**Re: Government of Canada's Response to the Comment Request for Agnico Eagle's
"Meliadine Extension" Project Proposal (NIRB File No. 11MN034)**

Appendix B: Government of Canada's New and Revised Technical Review Comments

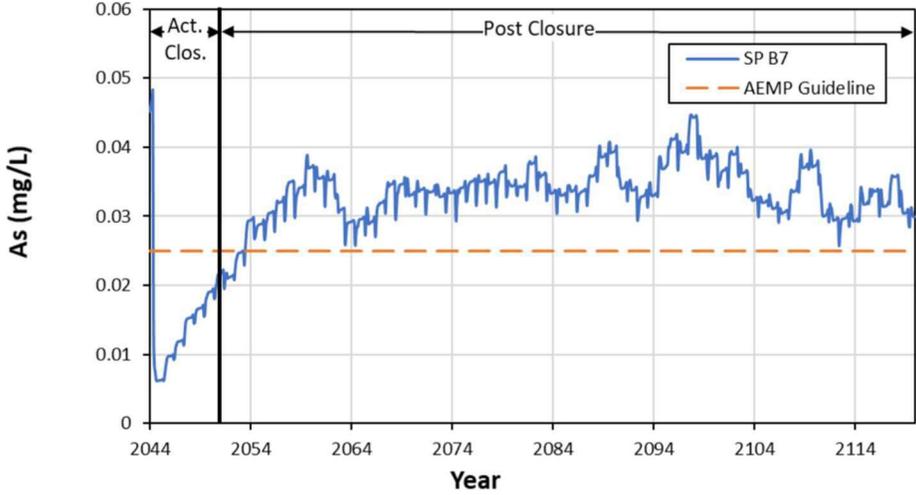
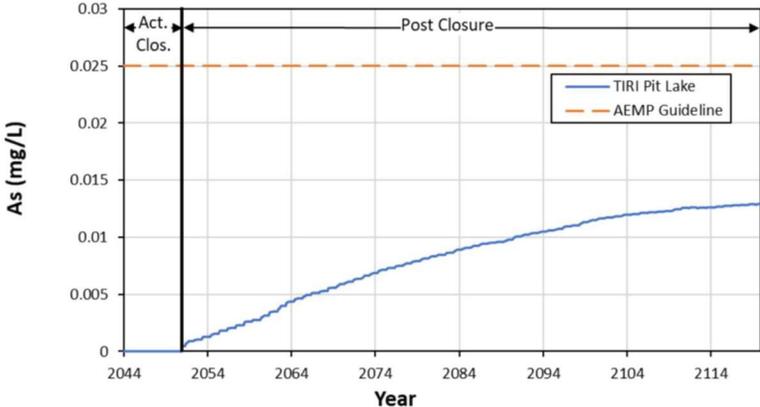
Detailed Review Comment	<p>Section 2.5.3 of the FEIS Addendum clearly indicates that exhausted open pits may be used as an alternative for temporary saline an surface contact water storage. However, other than identifying the pits that are being considered for water storage (i.e., TIR02, WES04 and WES05 see Fig 2.5-3), the FEIS Addendum and supporting documents do not contain any information on the alternative. For example:</p> <ul style="list-style-type: none"> The FEIS Addendum does not evaluate potential environmental interactions and impacts associated with temporary storage of contact water in pits; The Water Balance and Water Quality Model (Appendix H-07) does not account for storage of water in pits; and The Water Management Plan (Appendix D-35) does not describe how water stored in pits will be managed.

Review Comment #	CIRNAC-TRC-03
	<p>In summary, the FEIS Addendum and supporting documents present insufficient information to assess the environmental implications of storing water in pits. To address these information gaps, CIRNAC-IR-3 requested that Agnico:</p> <ol style="list-style-type: none"> a) Describe the approaches that will be used to store contact water in pits including general design parameters, operating practices and limitations (e.g., volumes stored, storage duration, any required treatment, eventual discharge to the environment); b) Describe the specific circumstances that would trigger the option to store contact water in pits; c) Describe the evaluations that would be done prior to regulatory approval of in-pit storage of contact water (e.g., updated site-specific hydrogeological and geochemical modelling); and d) Provide an assessment of potential environmental interactions and impacts associated with storing contact water in pits. <p>Agnico's response to CIRNAC-IR-3 provided limited additional information to address requests noted above. For instance, in the case of item a), Agnico indicated that the requested information would be addressed during the Type A Water Licence Amendment process with the NWB. With regard to item b), Agnico referred to documentation that has already been provided in the FEIS submission. For item c), Agnico states they will provide 60 days notice prior to initiating water storage in pits, but there is no indication that further studies will be performed. Finally, Agnico's response to item d) refers only to permafrost interactions and impacts, with no reference to other impact mechanisms (e.g., geochemical and/or hydrological interactions).</p> <p>In the absence of detailed responses to the requests presented in CIRNAC-IR-3, CIRNAC is unable to evaluate the environmental impacts of storing saline and surface contact water in pits.</p>

Recommendation / Request	<p>CIRNAC recommends that Agnico provide comprehensive responses to each of the following:</p> <ol style="list-style-type: none"> a) Describe the approaches that will be used to store contact water in pits including general design parameters, operating practices and limitations (e.g., volumes stored, storage duration, any required treatment, eventual discharge to the environment); b) Describe the specific circumstances that would trigger the option to store contact water in pits; c) Describe the evaluations that would be done prior to regulatory approval of in-pit storage of contact water (e.g., updated site-specific hydrogeological and geochemical modelling); d) Provide an assessment of potential environmental interactions and impacts associated with storing contact water in pits. At minimum, interactions and impacts should be assessed quantitatively for surface water quality/quantity and groundwater quality/quantity; and e) Provide evidence that contact water storage in mined-out pits is an environmentally superior alternative when compared to the currently approved water management practices.

Update (as of February 28, 2023)	<p>As mentioned in previously (see TRC #2 updates), Agnico provided additional information and clarifications prior to, and during, the February 6th meeting. CIRNAC considers this information adequate for environmental assessment (EA) purposes and looks forward to reviewing the additional information which Agnico has committed to provide during the NWB process.</p>
